UCI RESPONSE TO:

REQUEST FOR ADDITIONAL INFORMATION

UNIVERSITY OF CALIFORNIA IRVINE NUCLEAR REACTOR FACILITY

DOCKET NO. 50-326

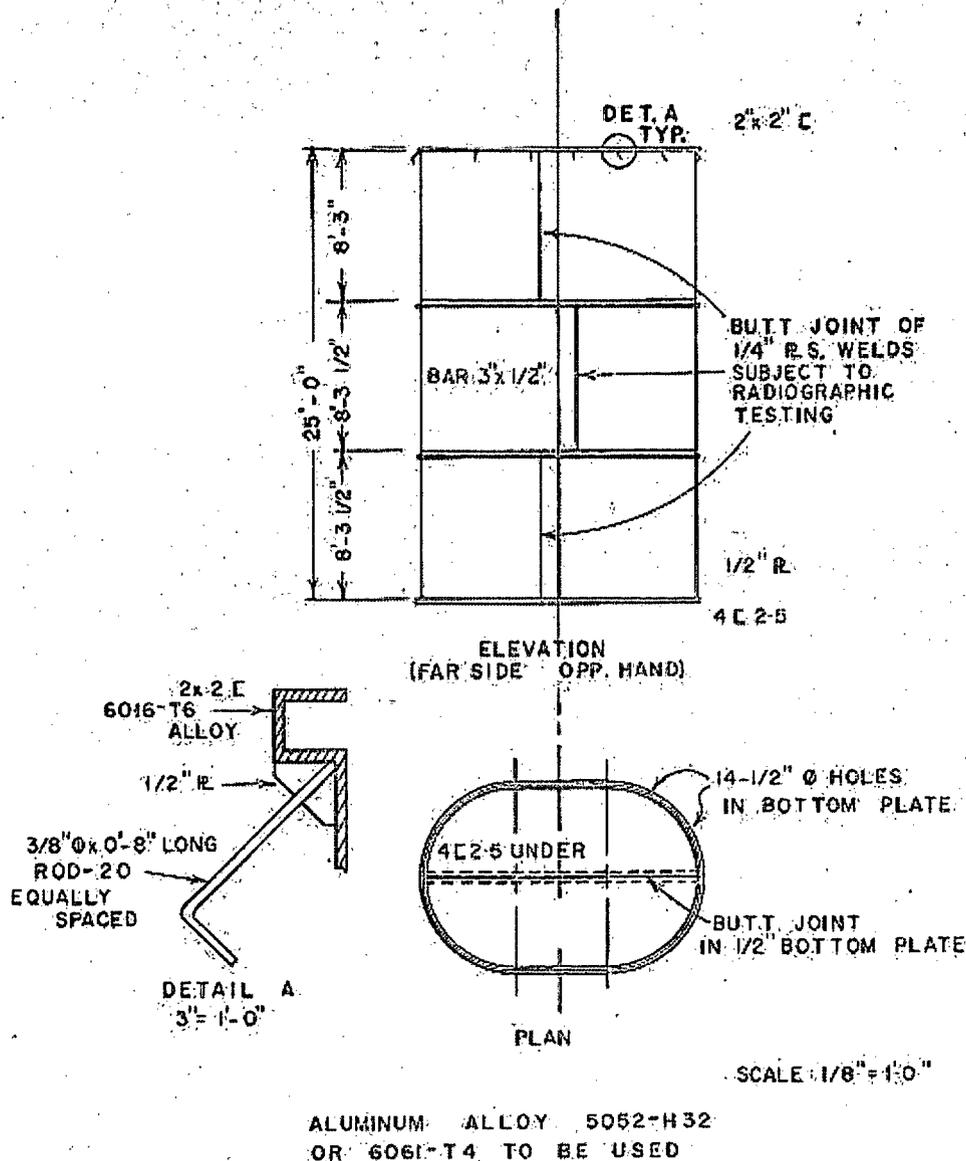
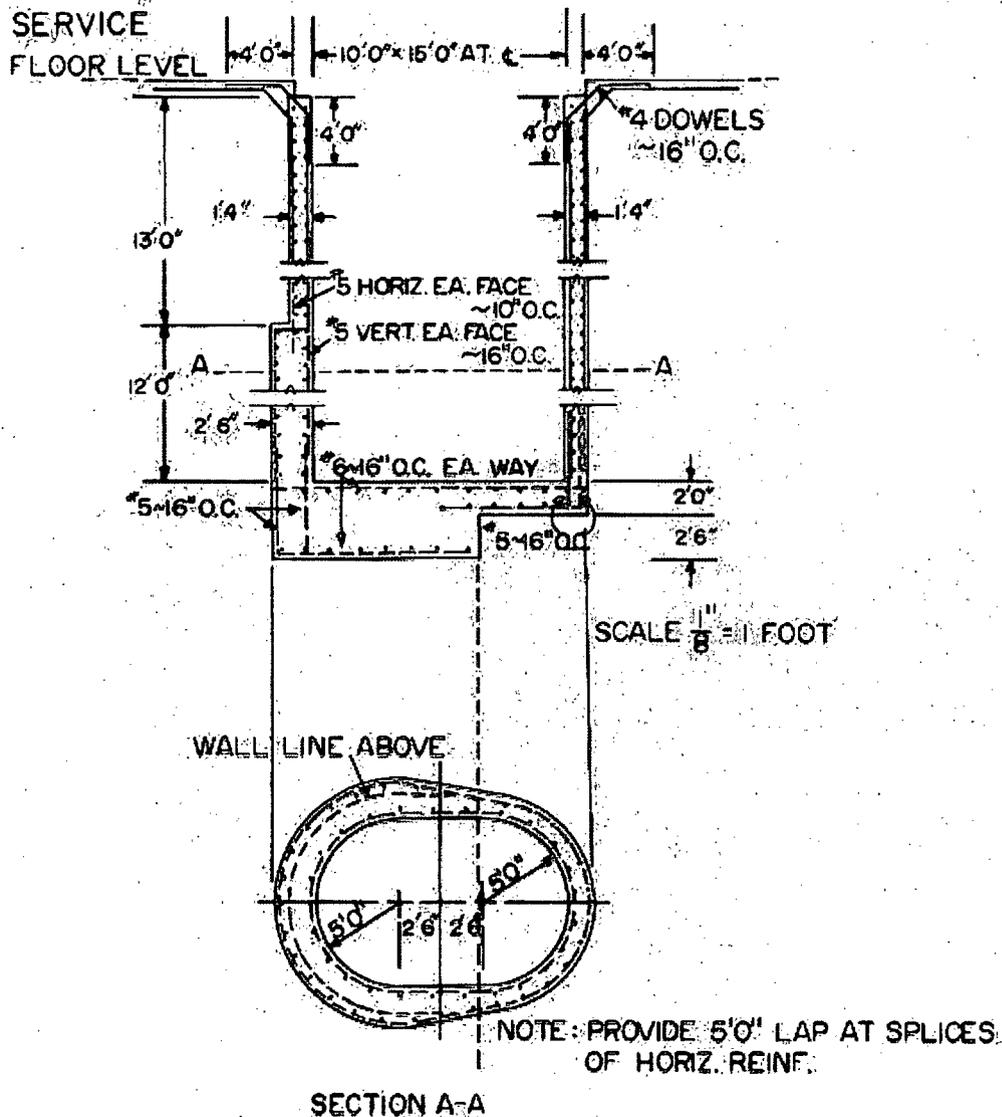
- (3) NUREG 1537, Chapter 4, "Reactor Tank and Pool," recommends that consideration be given to methods for assessing and preventing corrosion to the tank exterior. From the NRC's Inspection Report dated January 13, 2011, it is noted that ground water from rain and irrigation has been observed in fuel storage pits and in monitoring wells in the in- ground spaces around the exterior of the reactor tank. Please provide a discussion describing the impact to the reactor tank liner and other structures, as applicable, associated with this groundwater incursion. Since this groundwater incursion may cause corrosion, in your discussion, please describe how corrosion can be detected for the reactor tank and other structures, as applicable. Please include a discussion regarding detection of leakage from the reactor tank.

No evidence to this date of corrosion to the reactor pool tank from the outside has been detected, nor corrosion to other structures beyond that by incursion into the storage pits described to NRC in various communications several years ago. The tank is protected by impermeable wrapping as described in our SAR. However in order to mitigate the possibility of corrosion induced by the unanticipated ground water from the outside, the facility has recently installed a permanent pump and level measuring sensor in the closest monitoring well with the goal of maintaining the ground water level surrounding the pool tank to below the level of the concrete tank. This is more fully described in the revised SAR section 4.2 appended in full below.

The pool consists of an aluminum tank liner 10 ft wide by 15 ft long and 25 ft deep (Fig. 4-2), 1/4 inch thick on the sides and 1/2 inch thick on the bottom supported by reinforced concrete. At the core end, 2 ft 6 in of concrete surround the liner and 4 ft 6 in of concrete are below the liner to provide support and reduce soil activation (Fig. 4-3).
